CITY OF ALBUQUERQUE

**RE: Tuyet Son Buddhist Center
12125 Central Ave NE
Grading and Drainage Plan
Engineers Stamp Date 9/20/16 (L22D060)**

**TUYET SON BUDDHIST CENTER
LOT 2 BLOCK 5 HENDREN SUBDIVISION
12125 CENTRAL NE
Albuquerque, New Mexico**

Site Grading and Drainage Plan

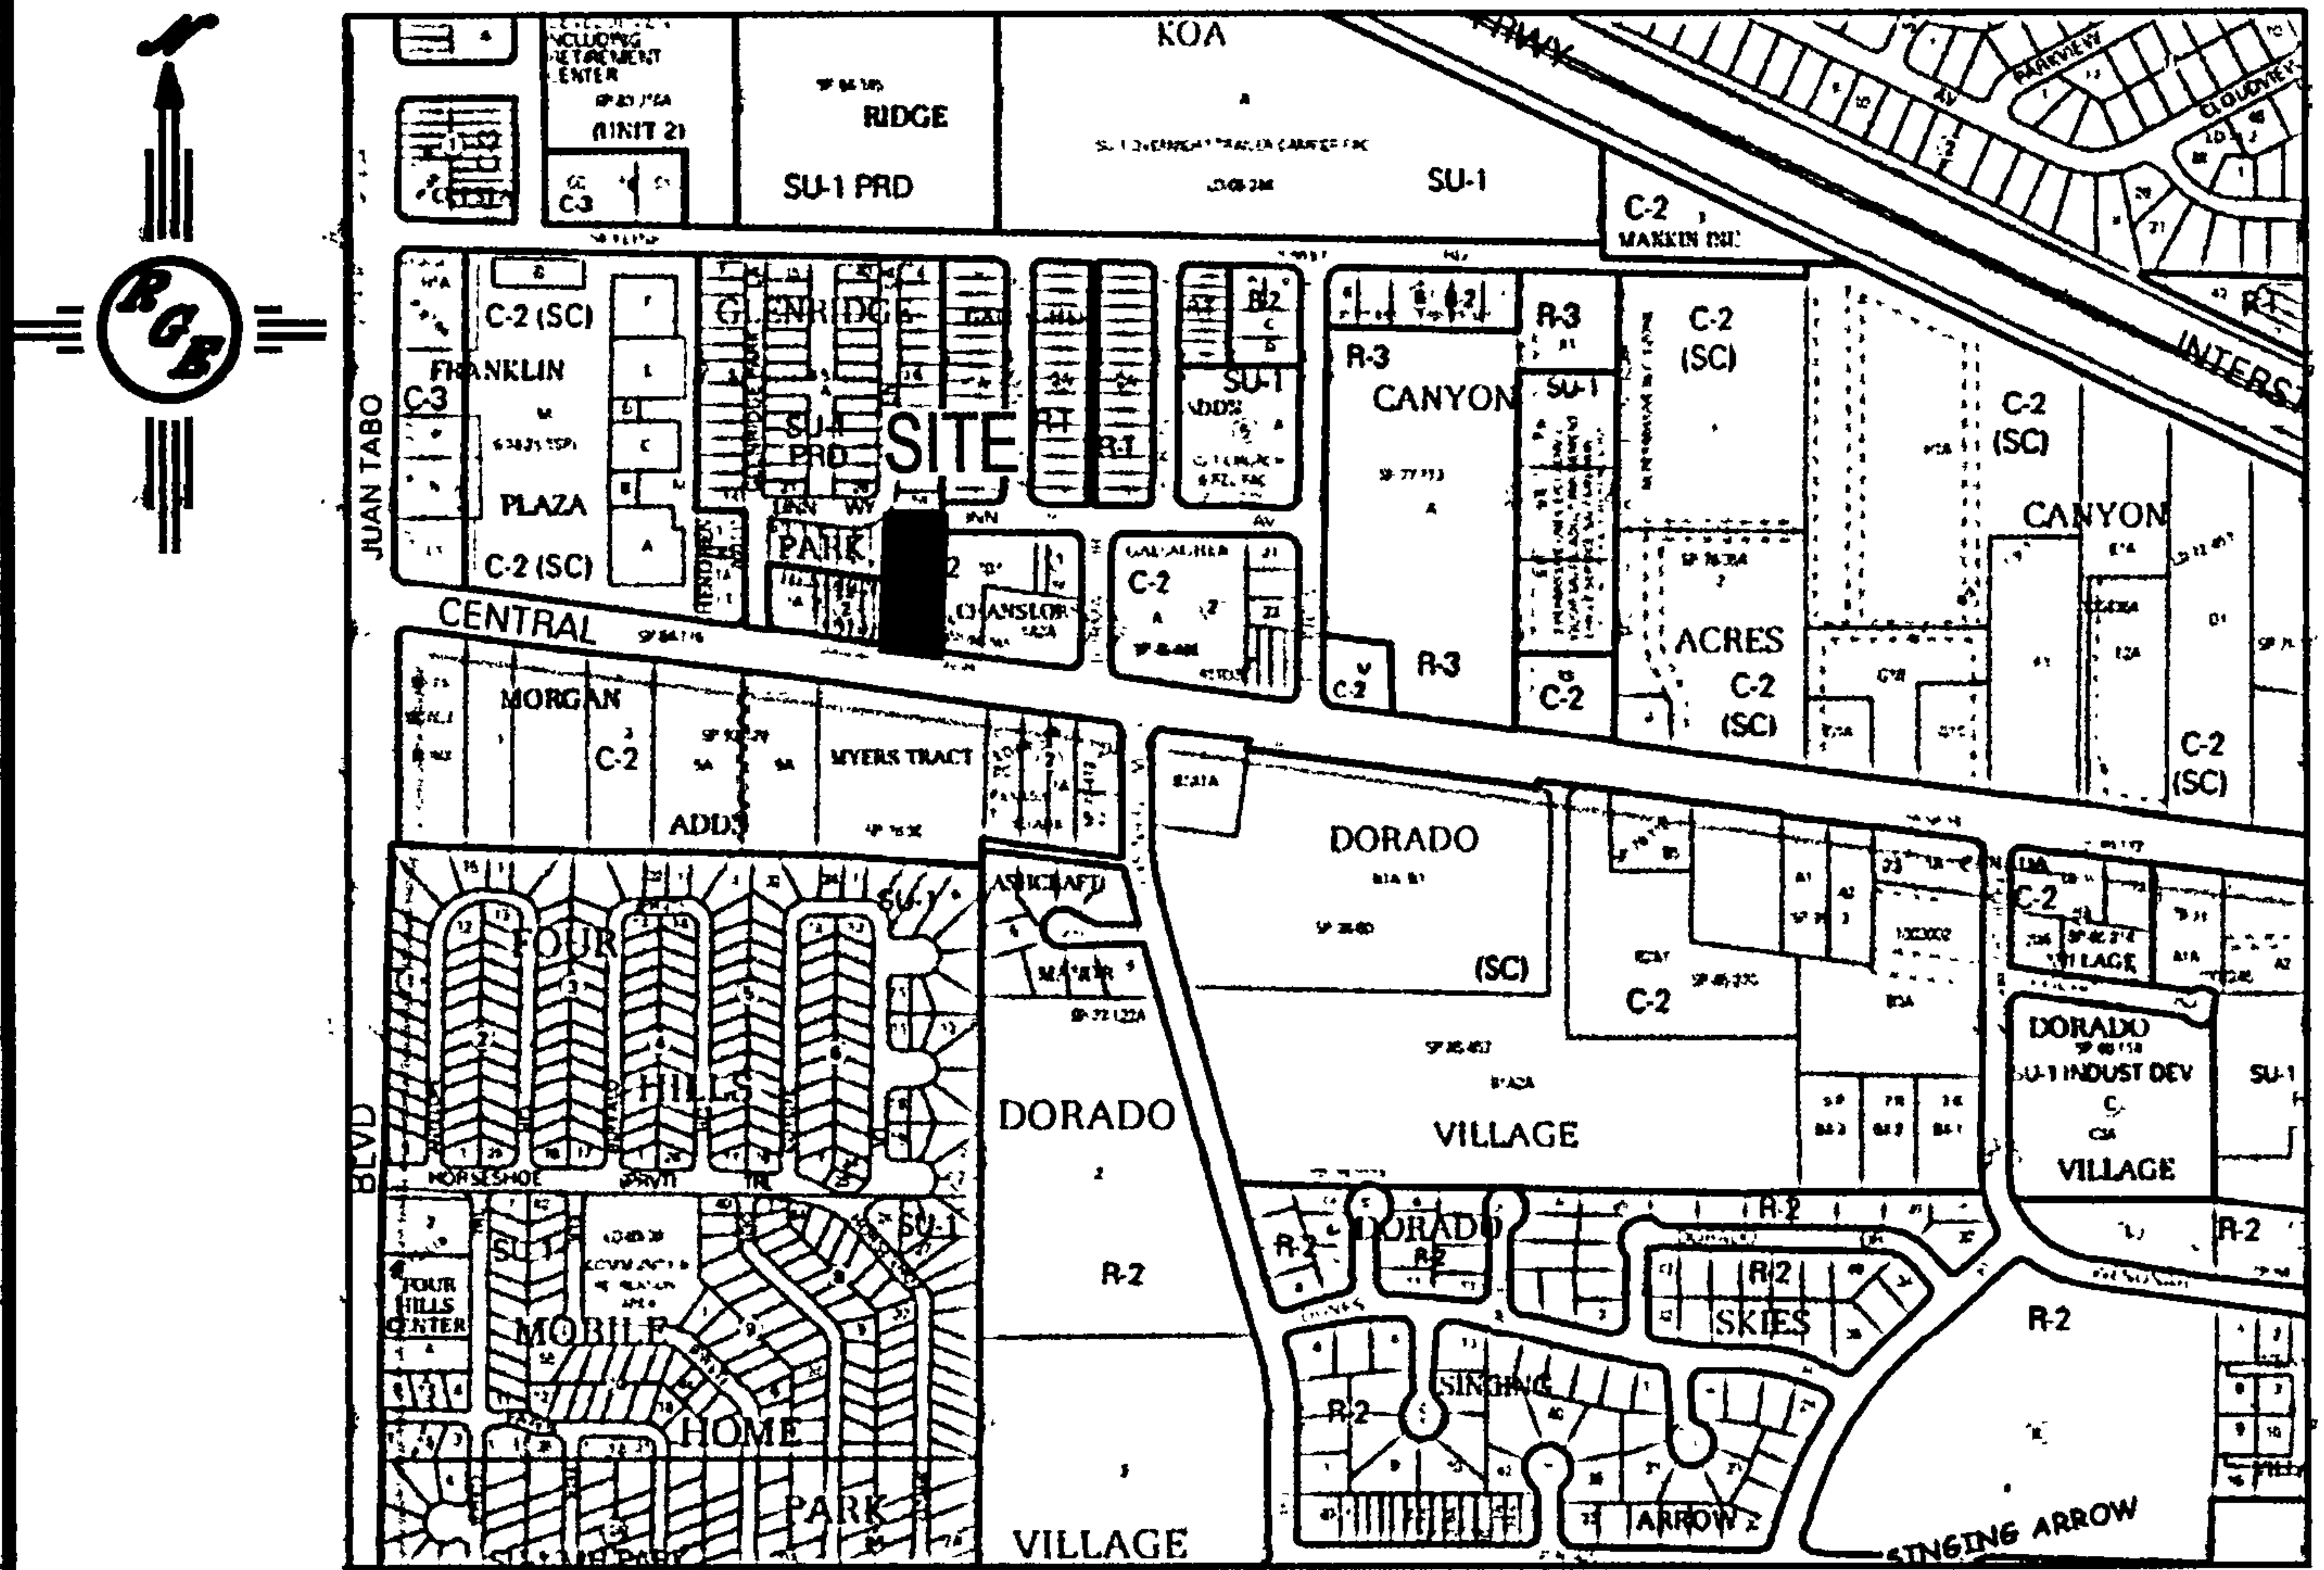
- Provide a detail for the compacted Berm. Will it be protected from erosion? we have added a berm detail
- At the northern end of the property there is a box with a door, is this a future building or a pond? We have labeled as a shed

- Are the ponds sized for the future buildings? We have accounted for the future buildings, but the site improvements to the buildings are not known, so the plan will need to be updated once a site plan is fully developed for the future buildings

- Are the dark lines between the existing pavement and new pavement curbing? We have labeled the curbs and edges of asphalt
- What is the double box at elevation point 53.00? we have labeled the motorcycle spaces

- Provide a water block at the entrance of this site. we have added a one foot water block
- Increase the font on the flow points in Central Ave. we have increased call outs of the flowlines on Central.

- At the front of the new building, is the dotted line a swale as called out in the center of the property? we have added call out and corrected direction of flow
If so, how will flows pass the sidewalk from east to west. Provide a detail or a note.

Please find the enclosed grading plan. We have revised the plan to address your emailed comments from 9/20/16. We have added a response in red as to how we addressed your comments.
